## 105-18-CA

### 536 E JONES STREET

Nature of Project:  
Replace two front doors,  
one second floor balcony  
door (after-the-fact); alter  
second floor balcony railing

## APPLICATION FOR A CERTIFICATE OF APPROPRIATENESS – STAFF REPORT

Original condition front right door (evidence of original blue is visible at bottom)

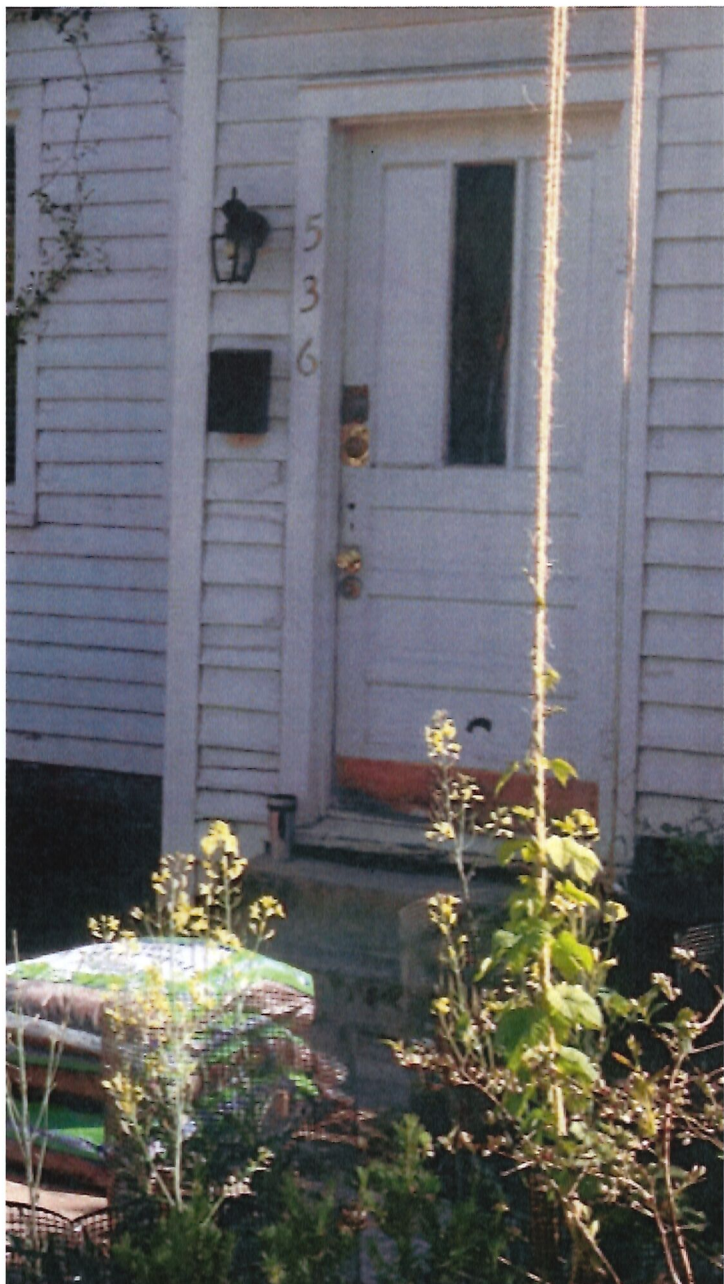
- 2\* The applicant provided a description and some photographs of the deteriorated state of the original doors. Documentation from craftsman experienced in the repair of historic wood doors that the doors were deteriorated beyond repair was not provided.

- 4\* The proposed doors do not match the design – panels and pane configuration – of the originals. Guideline 2.7.6 states “If a historic window or door unit is deteriorated beyond repair, replace the unit in kind, matching the design and the dimension of the original sash or panels, pane configuration, architectural trim, detailing, and materials. Consider compatible substitute materials only if using the original material is not technically feasible.”

The right front door, in addition to missing all 3 panes of glass, 2 filled in with plywood and a 3<sup>rd</sup> with chicken wire and plexiglass, has had 5 holes for doorknobs and deadbolts drilled into it. It had also been kicked in several times it appears and was missing large chunks from the center edge of the door where the original doorknob had been and also the bottom hinge side of the door. A fracture ran the over half the length of the door just to the center side of the (5) doorknobs/ locks. The bottom, which has cracks on both the doorknob and hinge side, was held together with the support of an additional piece of wood bracing attached at some point.

1. That the new doors match the design and the dimension of the original door including panels and pane configuration, architectural trim, detailing, and materials.
2. That details and specifications for the following be provided to and approved by staff prior to issuance of the blue placard:
  - a. Detailed drawing of the proposed balcony railing;
  - b. Manufacturer's specifications of the replacement doors

Detail of right front door (outside)

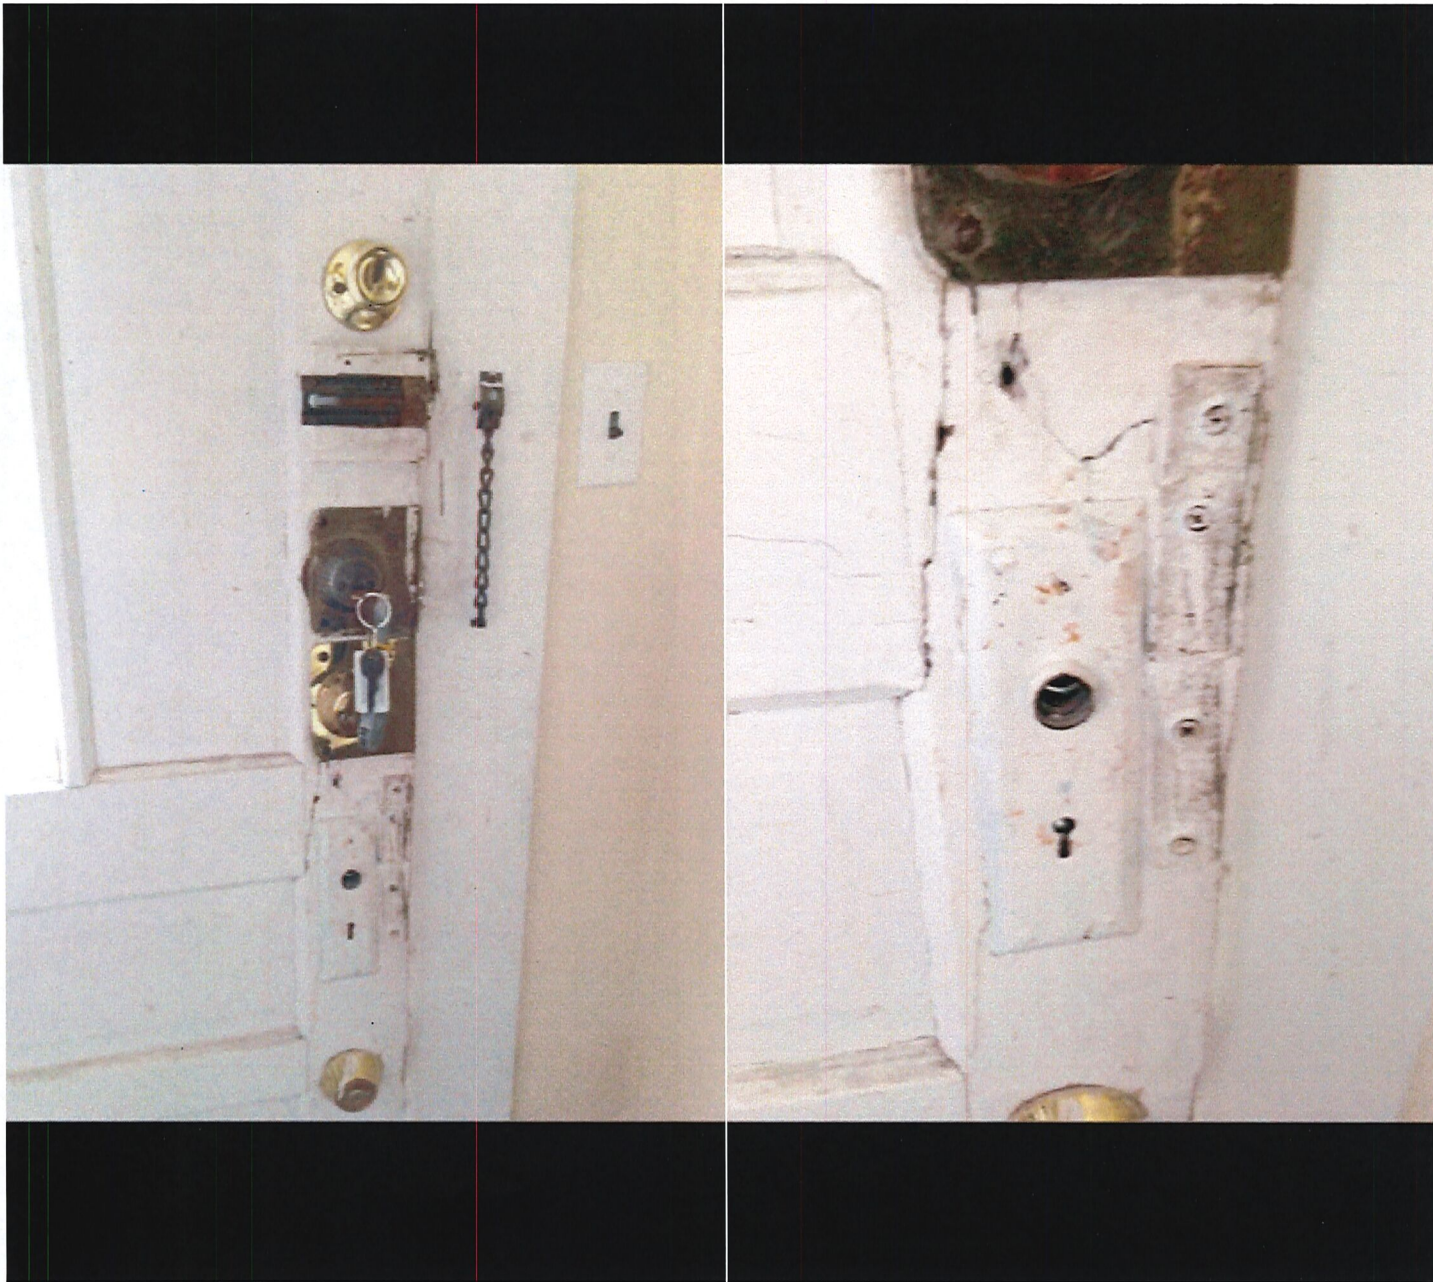
Interior right front door (shows full length split, metal bracing, and 5 separate holes for locks and knobs)

**Large chunk missing from inside front right door. Also shows more cracking and extra wooden bracing applied to help keep the door together.**

Front left door detail. Shows significant pieces missing from (what appears to be) forced open at some point.

Front left door prior to staining (notice reuse of the casing.

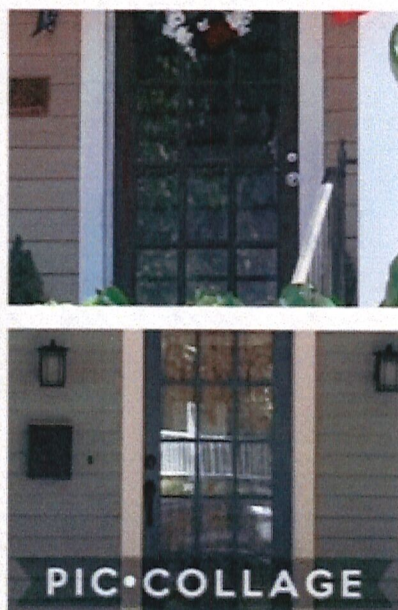
- 3\* Two new wood-framed half-lite doors are proposed for the first floor of the front facade. Two new full-lite doors are proposed for the second-floor balcony of the front façade and the rear.

The replacement front bottom doors, both left and right, have 9 short panes, filling the same space, as the 3 long panes of the originals. The reason for the slight difference is that identical doors were not technically feasible. After a search of numerous vendors in the area, the design is not available. An exact replication would have to be specially designed and built, at a cost several thousand dollars more than the very similar replacements that were commercially available.
